Tennessee Valley Authority, 1101 Market Street, LP 5A, Chattanooga, Tennessee 37402-2801

Docket No. 52-014 and 52-015

BELLEFONTE COMBINED LICENSE APPLICATION – RESPONSE TO REQUEST FOR
ADDITIONAL INFORMATION – EVALUATION OF POTENTIAL HAZARDS – IDLH
CONCENTRATIONS

NRC RAI NUMBER: 02.02.03-08

Figure A1: Limiting Case run with HABIT V 1.1 code and the JAVA Language Extended version of HABIT

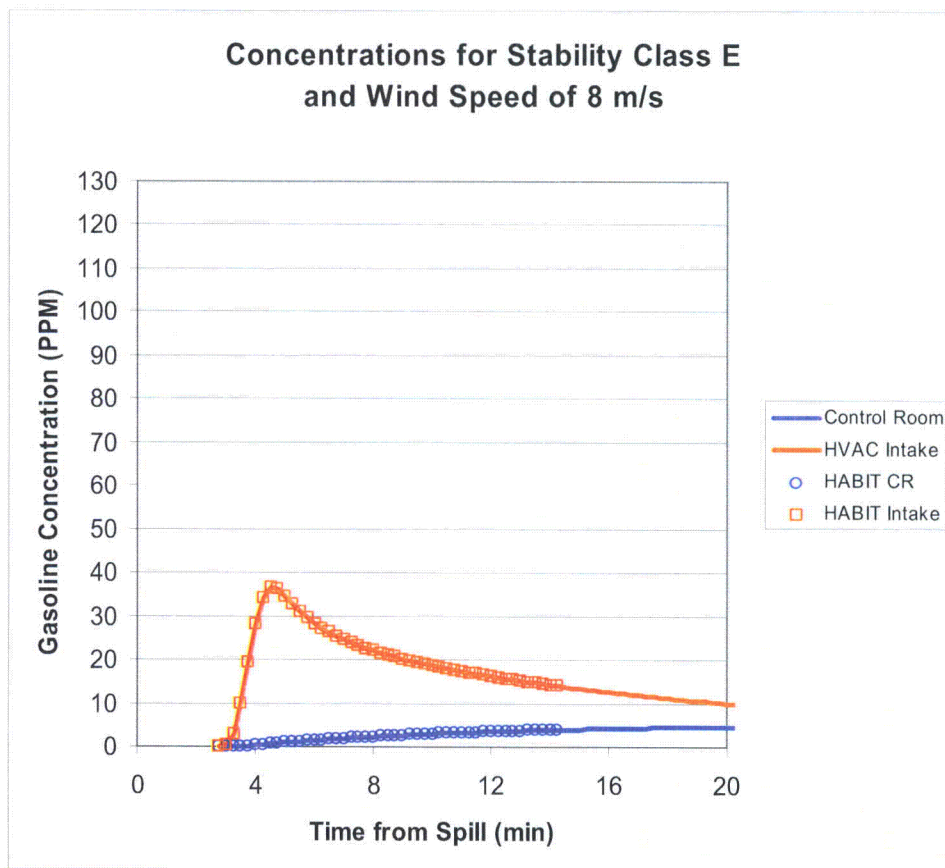
RG 1.206 provides guidance regarding the information that is needed to ensure potential hazards in the site vicinity are identified and evaluated to meet the siting criteria in 10 CFR 100.20 and 10 CFR 100.21. The IDLH concentrations of gasoline (300 ppm, 1227 mg/cu.m), ammonia (300 ppm, 209 mg/cu.m), and propylene oxide (400 ppm, 949 mg/cu.m) are lower than the applicant's screening criteria. Justify the use of the screening criteria with higher than IDLH concentrations and how they relate to control room habitability. In addition, based on the applicant's provided information (Tables 2.2-215 and 2.2-216), chemicals with IDLH concentrations considered for barge transport, styrene (2978 mg/cu.m), ethanol (6209 mg/cu.m), sodium hydroxide (10 mg/cu.m), pose a concern for control room habitability. The staff's independent analysis shows that the concentrations of these chemicals exceed the respective IDLH concentrations at the intake of the control room. Provide a basis for why these chemicals do not pose a potential control room habitability issue.

were translated into JAVA programming language and recompiled with a minimum of modification. The alternate analysis used the same toxic gas transport and dispersion modeling methods and properties as applied in the HABIT V1.1 code. The results of the alternative analysis were superimposed onto the representation of HABIT V 1.1 code in Figure A1 to confirm agreement.

Since under no condition is the exterior concentration above the IDHL value of 300 ppm, nearby transport of gasoline poses no threat to control room habitability. The limiting case for gasoline, 8 m/s Class E, is also run with the HABIT V 1.1 code. The results are identical, as seen in Figure A1.
